Subject: MHI's Response to US-APWR DCD RAI No. 504-4028 REVISION 2

Responses to Request for Additional Information No. 504-4028 REVISION 2

US-APWR Design Certification Mitsubishi Heavy Industries Docket No. 52-021	
RAI NO.:	NO. 504-4028 REVISION 2
SRP SECTION:	09.05.06 - EMERGENCY DIESEL ENGINE STARTING System
APPLICATION SECTION:	9.5.6
DATE OF RAI ISSUE:	12/1/2009

Figure 9.5.6-1 Gas Turbine Generator Starting System Schematic Diagram

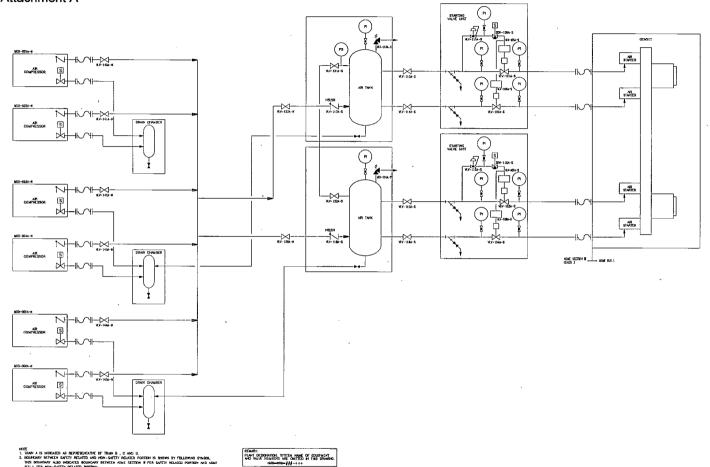
The revised Figure 9.5.6-1 shows an ASME Section III/ASME B31.1 boundary at the piping inlet to the GT skid. The figure should also show the ASME Section III boundary at the air receiver inlet check valve. This boundary is shown as NS/SR. Note also that this symbol does not agree with the corresponding note on this figure - the note identifies the abbreviation as SR/NR, not NS/SR.

NOTE about boundary at inlet check valve of air receiver will be revised to identify boundary between ASME section III and ASME B31.1

NOTE 2 in Figure 9.5.6-1 will be revised as follows:

Boundary between safety related and non-safety related portion is shown by following symbol. This boundary also indicates boundary between ASME section III for safety related portion and ASME B31.1 for non-safety related portion. SRINR: Safety Related | Non-Safety Related NS|SR: Non-Safety Related | Safety Related

Based on above, Figure 9.5.6-1 will be revised as shown in Attachment A.
